COMMITTEE OF THE WHOLE OCTOBER 18, 2004

**ZONING BY-LAW AMENDMENT APPLICATION FILE Z.04.055
SITE DEVELOPMENT FILE DA.04.032
AMORINO RIDGE DEVELOPMENTS INC.**

Site Plan (Outparcel)

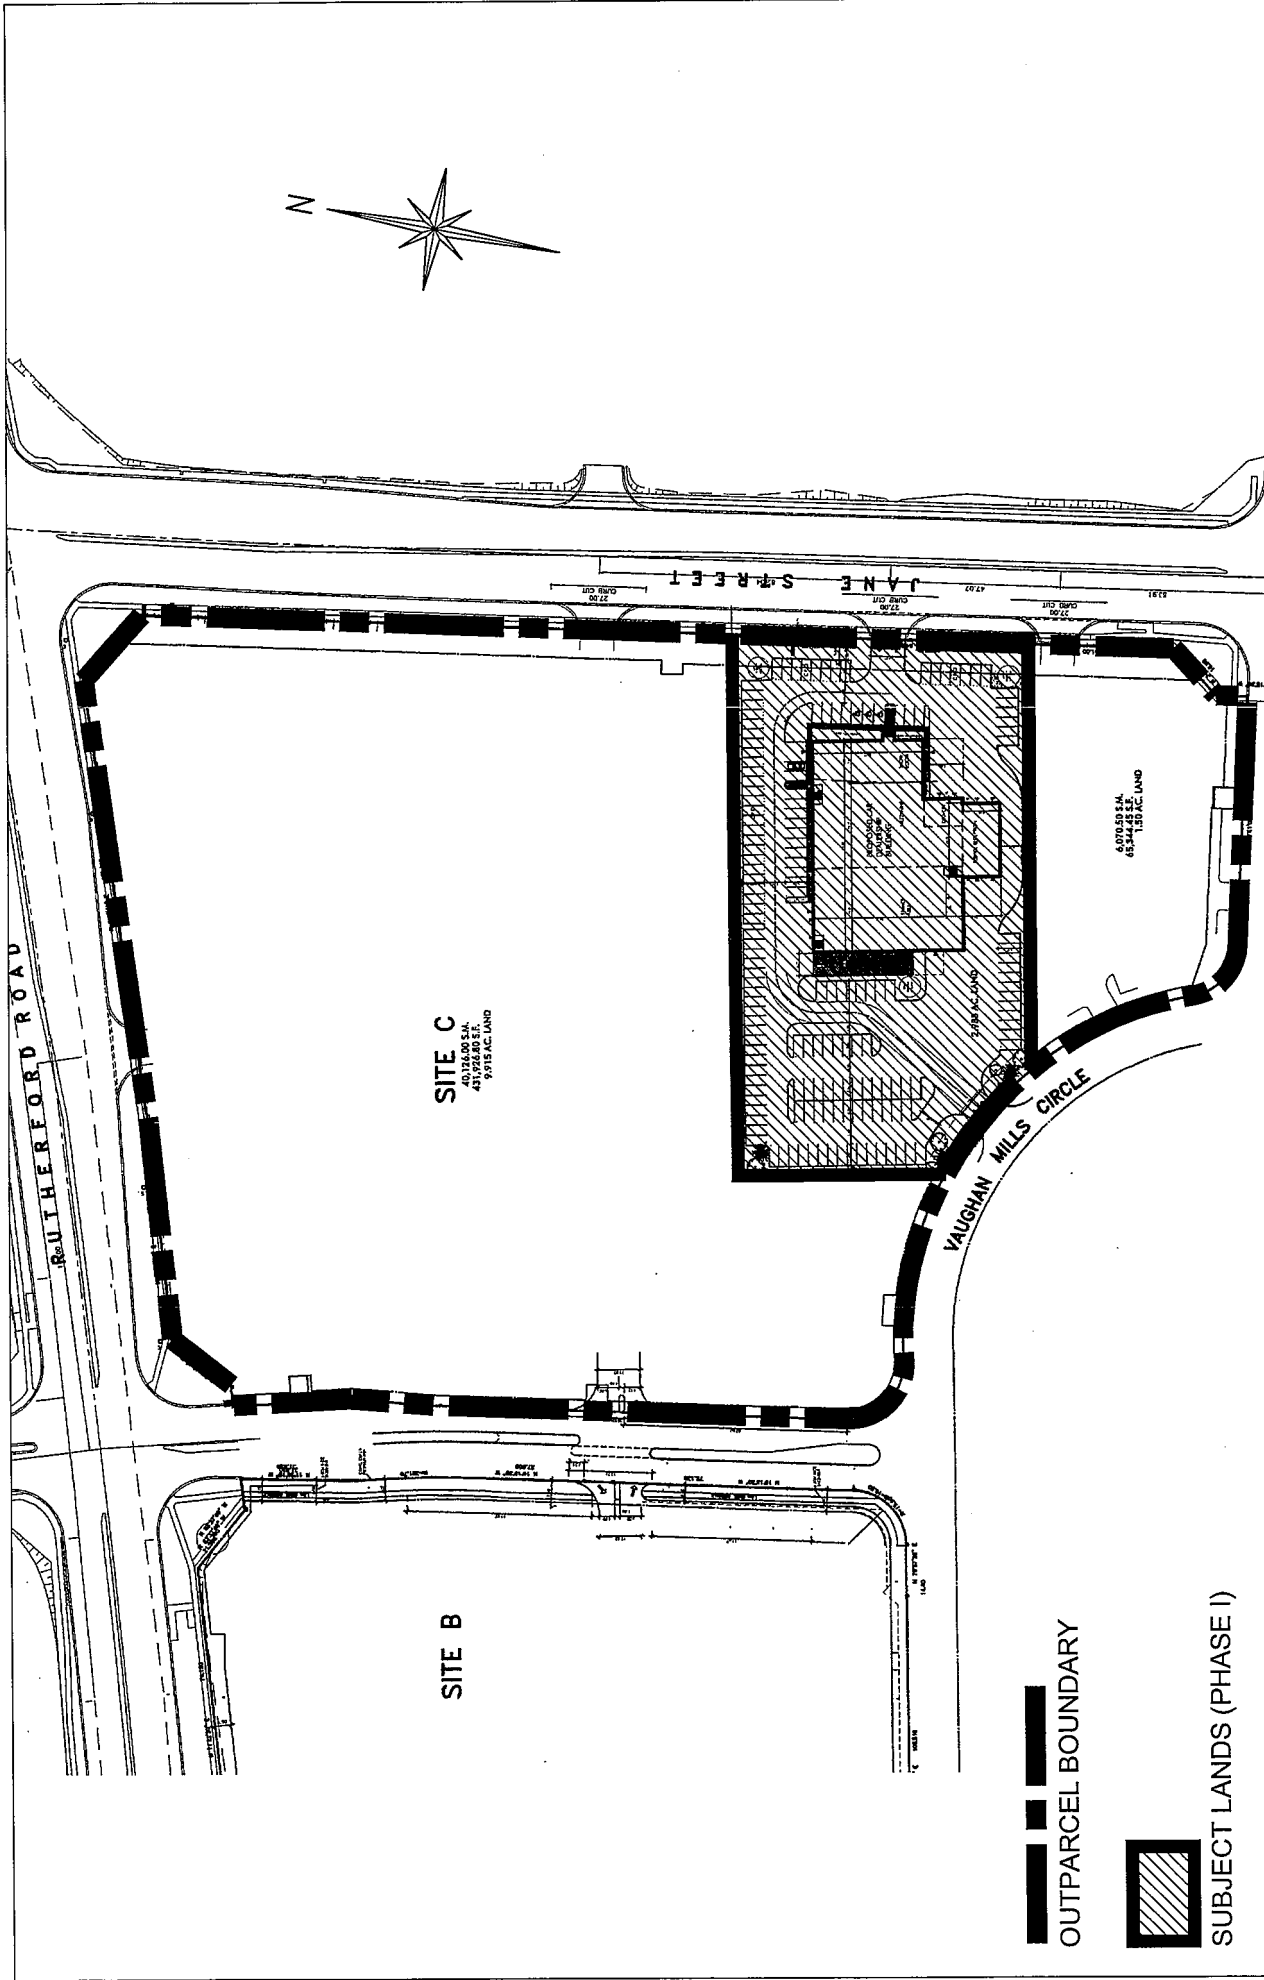
Vehicular access to the site is proposed from Jane Street and Vaughan Mills Circle. The proposed site plan represents part of the larger Vaughan Mills outparcel. The outparcel site plan (Attachment #2) illustrates that three driveways are proposed into the larger outparcel site from Jane Street which has been approved by the Region of York.

Site Plan Phase I (Detailed)

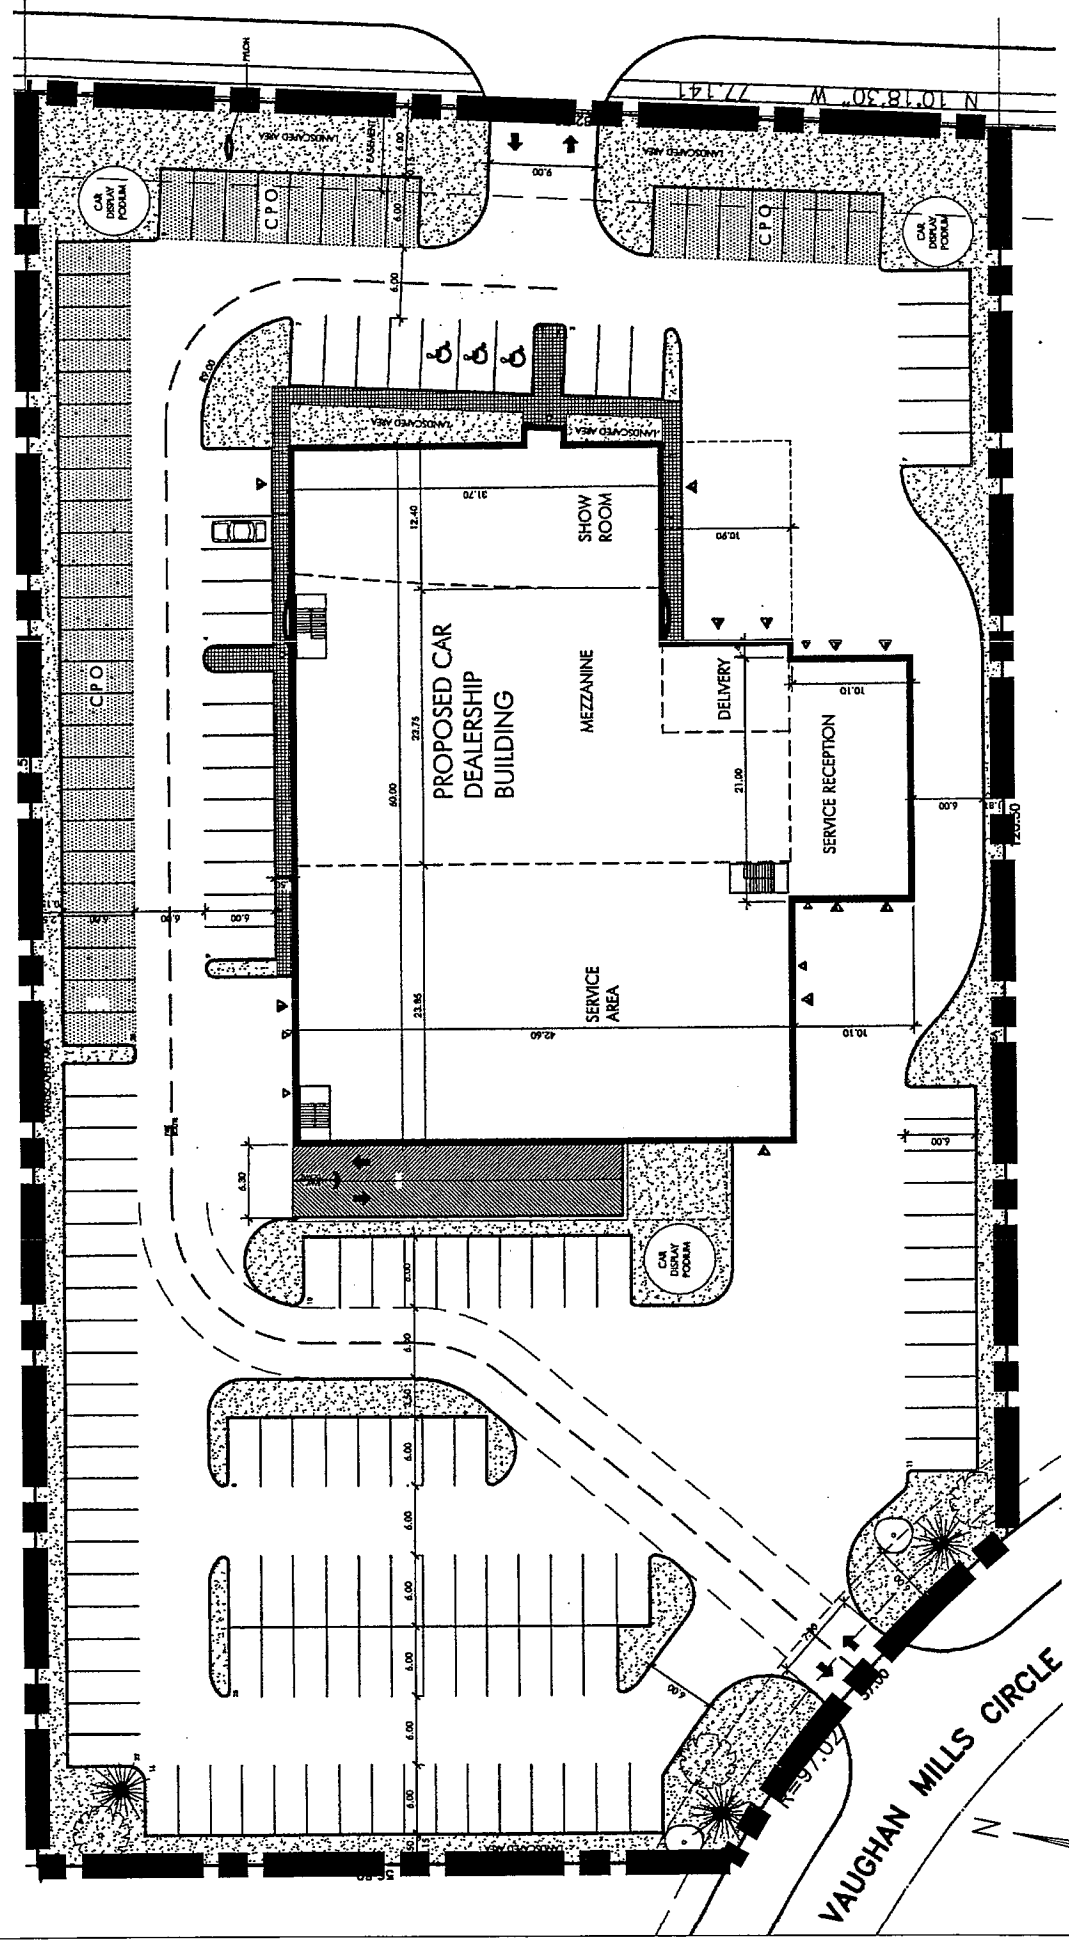
The site is zoned C1(H) Restricted Commercial Zone with the Holding Symbol "H", and subject to Exception 9(1030). The Building Standards Department has advised that a loading space is required for the proposed car dealership. The site plan will be revised to designate loading spaces in front of one of the overhead doors not facing Jane Street, to satisfy this by-law requirement. Otherwise, the proposal conforms to the zoning by-law.

The site plan shows one building with the main front entrance facing Jane Street, set back approximately 26.5 metres from the Street. A ramp located at the rear of the building provides access to 80 subsurface parking spaces. The balance of the 162 parking spaces is distributed throughout the site with the largest parking area located at the back of the building. Pedestrian access to the site will be provided from Jane Street and Vaughan Mills Circle, and the site plan will be amended to delineate all pedestrian connections into and within the site.

A 6m wide landscape buffer strip is provided along Jane Street, with the balance of the landscaping around the perimeter of the site ranging from 1.8 to 2.5 metres in width. Car display podiums are located at the northeast and southeast corners of the property, with an additional podium west of the building. Final details of the car podium display areas must be provided. The pylon sign shown abutting Jane Street is located over a sewer easement that runs across the property's frontage and must be relocated. The garbage room is not shown on the proposed plan but must be enclosed and located within the building.

Elevations

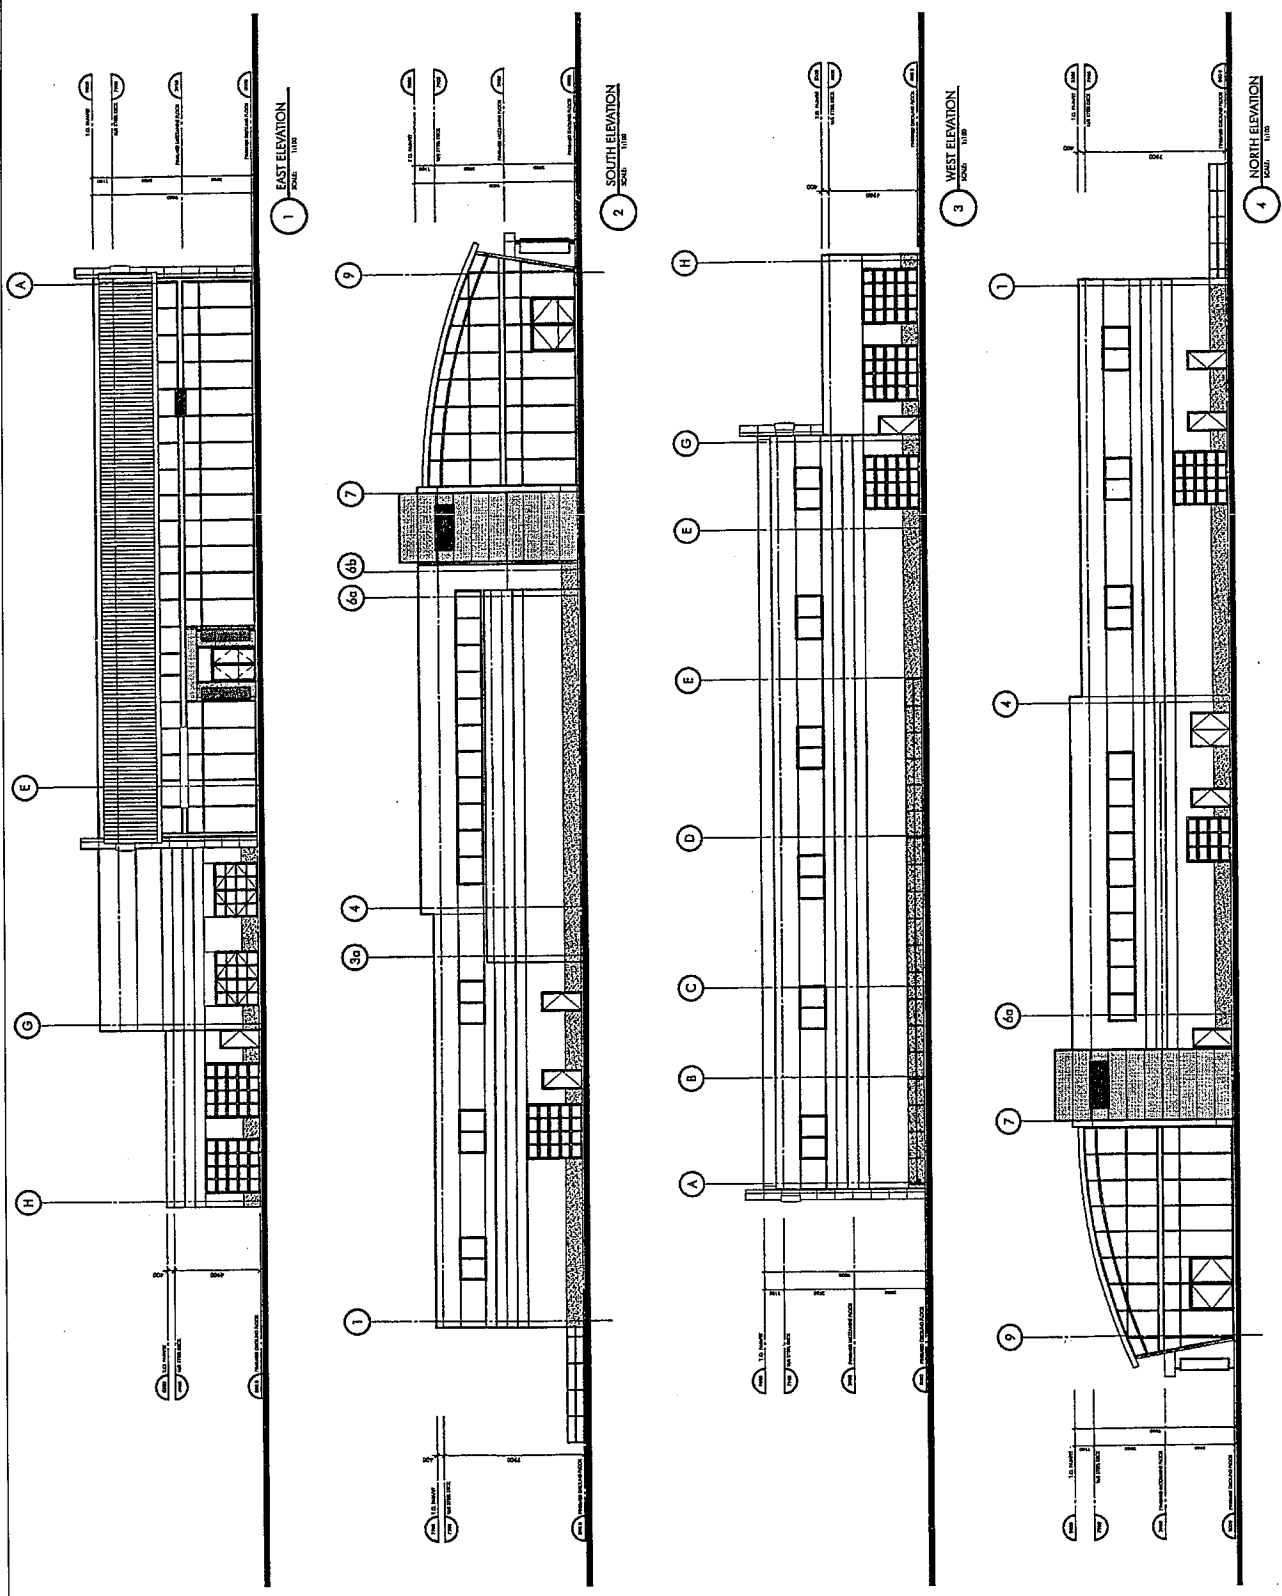
The main front (east) elevation is comprised of two distinct parts, each with a different architectural treatment as shown on Attachment #4. The main part of the building, which includes the dealership showroom and closest to Jane Street, is primarily constructed with double glazed clear window units in steel frames. The roof over this part of the building is curved, sloping downward toward the front of the structure and constructed with a silver coloured metal roofing material. The main front entrance is covered. The second part of this elevation is setback an

additional 15 to 16 metres from the street and includes the delivery and service bay areas. The height of the building drops from 9 metres over the delivery area to 5.3 metres for the service bay. This part of the front elevation is treated with white precast concrete panels with gray accent banding and includes four large service doors made of glass and steel.

The side and rear elevations consist primarily of white precast concrete panels with gray accent banding. Windows are provided on the upper level of each elevation. A dealership pylon sign with logo forms part of the north and south elevations. The sign is constructed with prefinished curved aluminum panels in a silver colour. Service bay roll-up and man doors are proposed on each of these elevations. The south and west elevations of the building will be visible from Vaughan Mills Circle and should be enhanced through the use of architectural treatments to create the "four-sided" architecture outlined in the Vaughan Mills Design Guidelines for outparcel development.
